# Residual ISI Specification

Alexander Rysin and Piers Dawe, NVIDIA

# Case 1 – No TX FFE, no RX CTLE

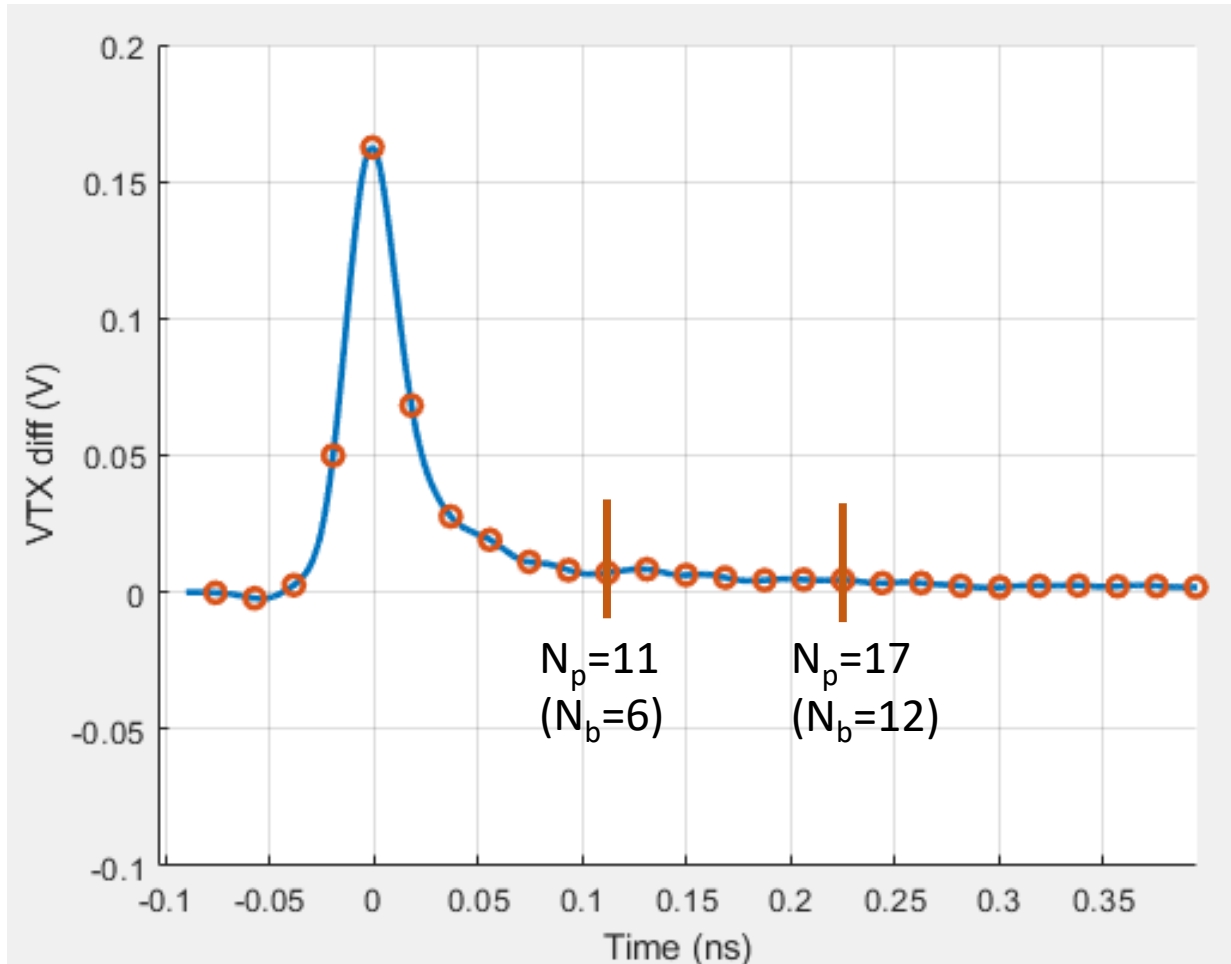
$N_p=11$  (6 post cursors)

**ISI\_RES = -22.8694 dB**

$\sigma_e = 0.0117$  V

Current specification – ISI\_RES < -30 dB  
with  $N_p=11$

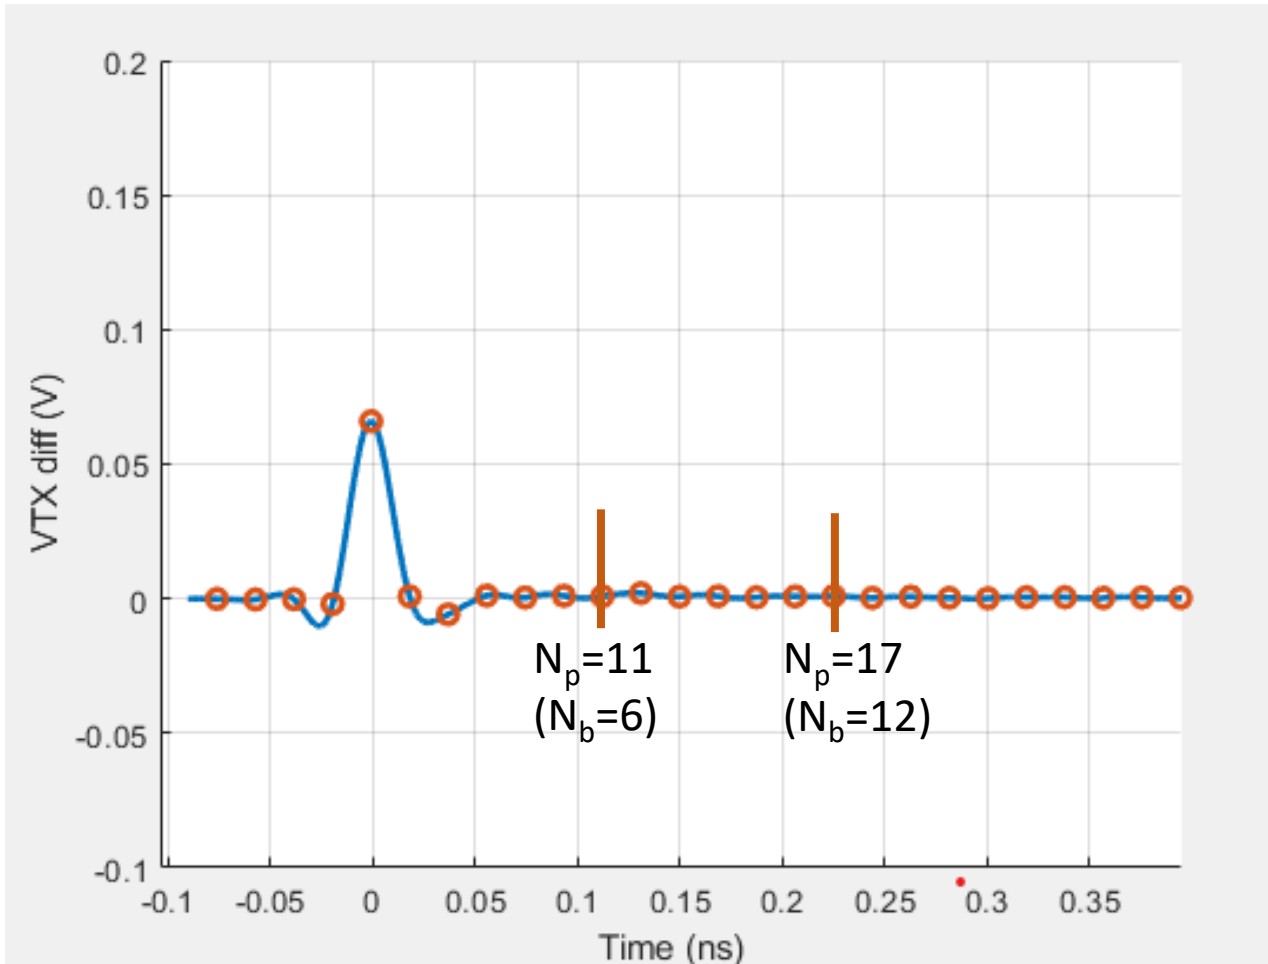
$N_p=17$  (12 post cursors)

**ISI\_RES = -27.1311 dB**

$\sigma_e = 0.0071$  V

# Case 3 – No TX FFE, with RX CTLE

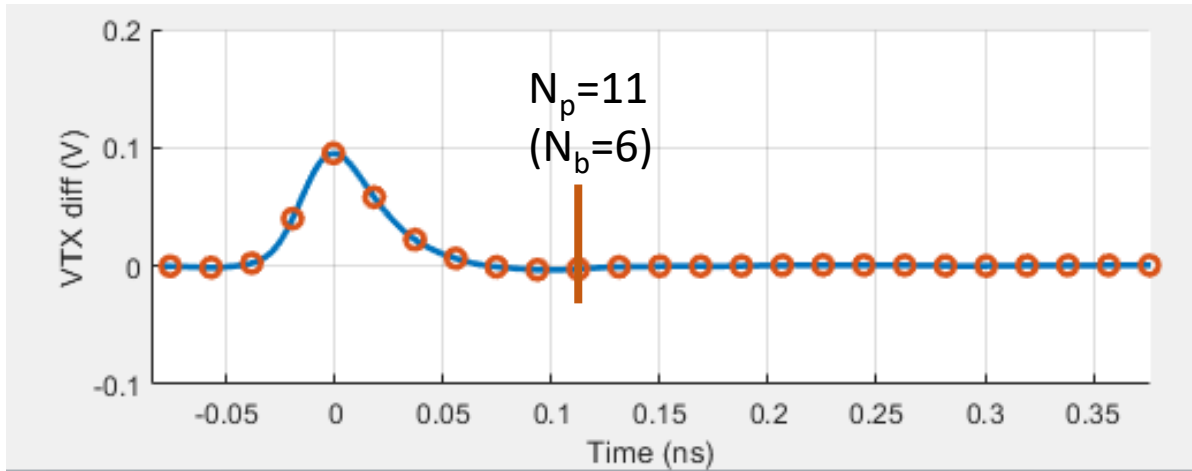
$N_p=11$  (6 post cursors)

ISI\_RES = -31.3379 dB

$\sigma_e = 0.0026$  V

$g_{DC} = -5$

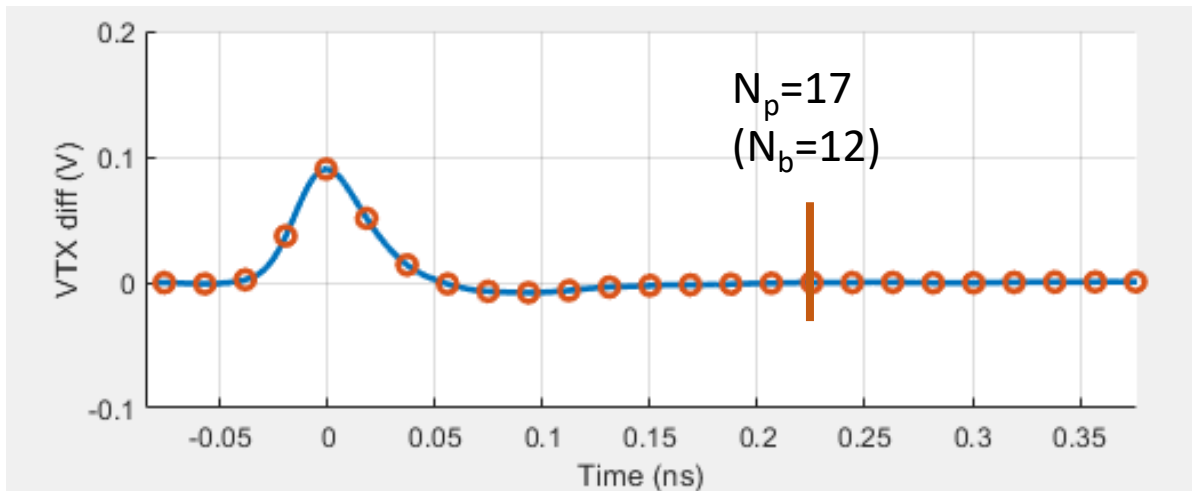
$g_{DC2} = -2$

$N_p=17$  (12 post cursors)

ISI\_RES = -33.4291 dB

$\sigma_e = 0.0019$

$g_{DC} = -8$

$g_{DC2} = -1$

Current specification – ISI\_RES < -30 dB  
with  $N_p=11$
